SUBJECT: Summary of the public process and comments received on the proposal for bicycle lanes on Western Avenue.

This memorandum presents a summary of the public process and comments received on Saint Paul Public Works' proposal to install bicycle lanes on Western Avenue between Front Avenue and Como Avenue. The full text of all written statements received is attached to the end of this memorandum.

Western Avenue Bikeway Project Meeting

EXISTING

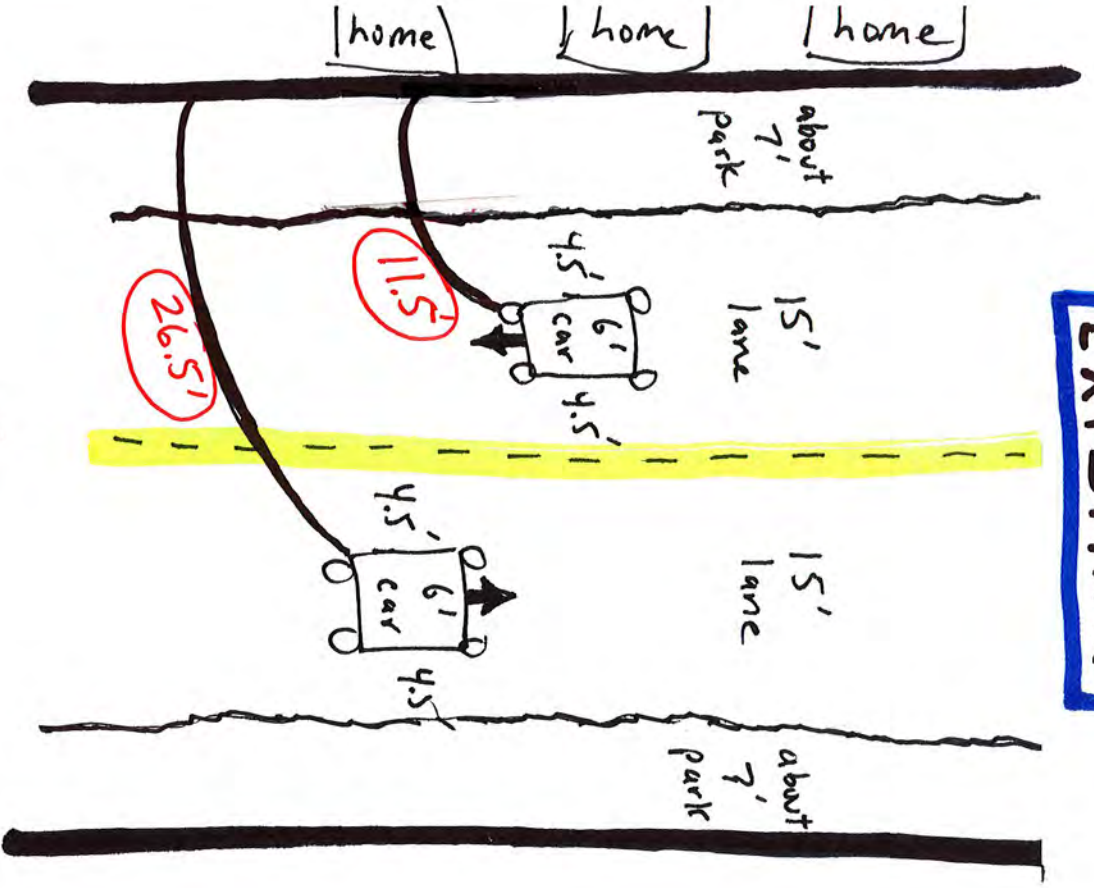
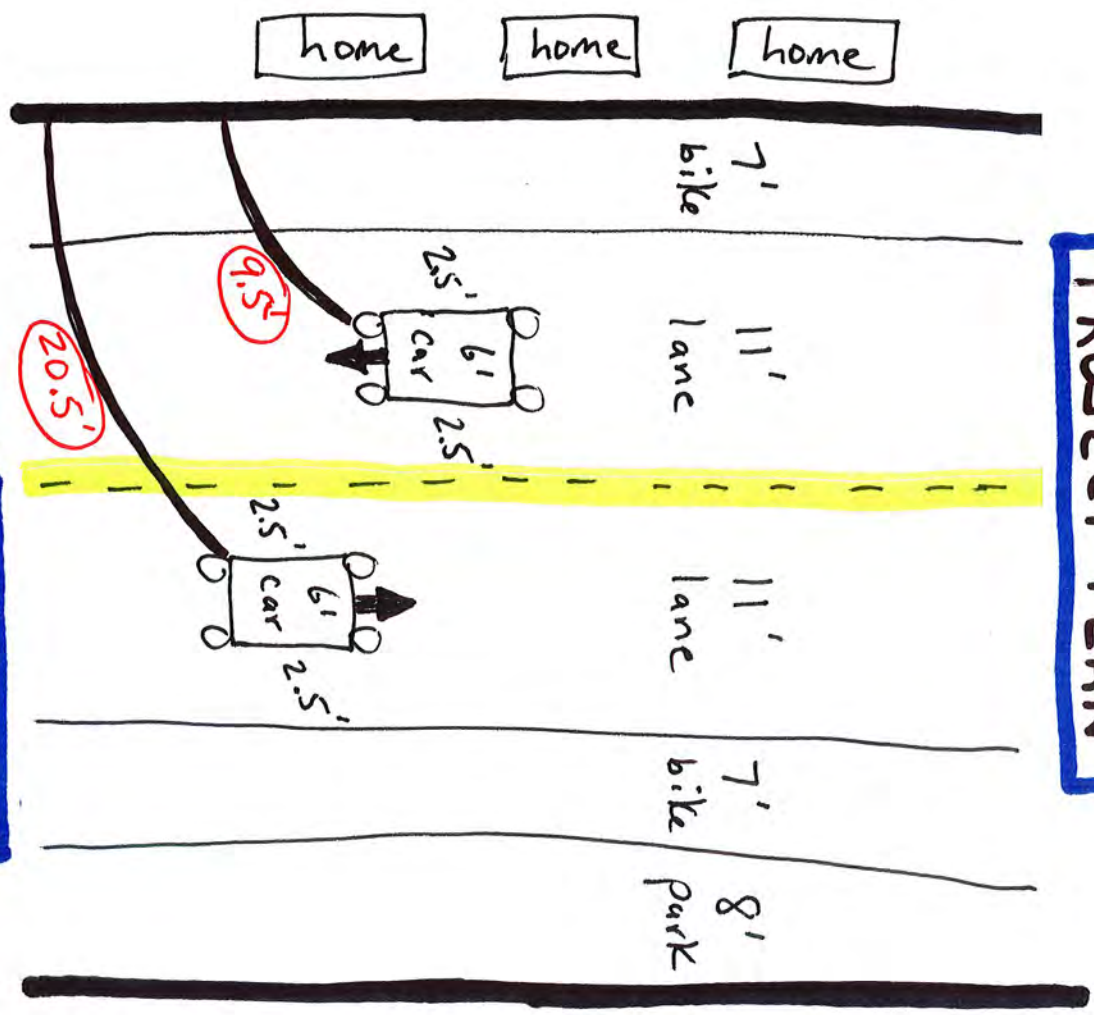
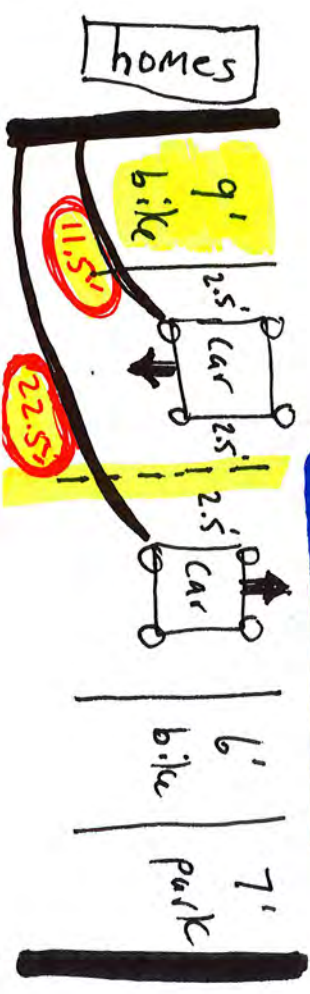
Please consider making the West side bike lane (cushion) as wide as possible. The current level of traffic noise and vibration is quite bad especially South of Front Street.

Could East side parking lane be reduced to 7.5 feet, 7 feet or 6.5 feet in your plan?

Could East side bike lane be reduced to 6.5 feet, 6 feet, or 5.5 feet in your plan?

Combinations of these would allow a "cushion" of up to 2 feet to be added to the bike lane on the West side.

PRESENTLY assuming cars travel in the center of lane, existing South bound cars are 11.5' from West curb edge
PRESENTLY assuming cars travel in center of the lane, existing North bound cars travel 26.5' from West curb edge

In the project plan, the South bound car would travel at 9.5' from West curb edge

In the project plan, the North bound car would travel at 20.5' from West curb edge

It is the **North bound lane that is getting moved over a significant amount, about 6 feet further West** than current traffic flow. This will significantly increase noise and vibration for our homes on the West side, especially when speeds are well over 30 MPH.

ADD 2 FEET?

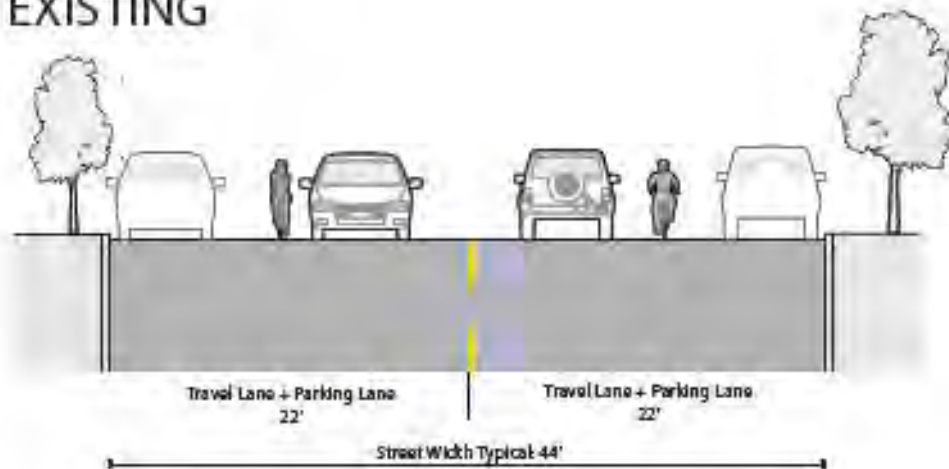
The mailing is misleading. It represents Western in a diagram and states typical width is 44'. Western Avenue where I reside is 40' wide.

The section of Western south of Como that you said is an example of a 7' lane, is not a 7' lane as shown in the proposed diagram. That part of Western has a 5' blacktop lane on the west side and a 6' blacktop bike lane on the east side along with a 7' parking lane.

Could you also give me an example of a currently existing bike lane that is 7 feet wide next to the curb as is pictured in the Western Avenue flyer. I have drove down Prior, Front and Minnehaha and cannot seem to find a 7 foot wide path that would be representative of the Western Avenue proposal.
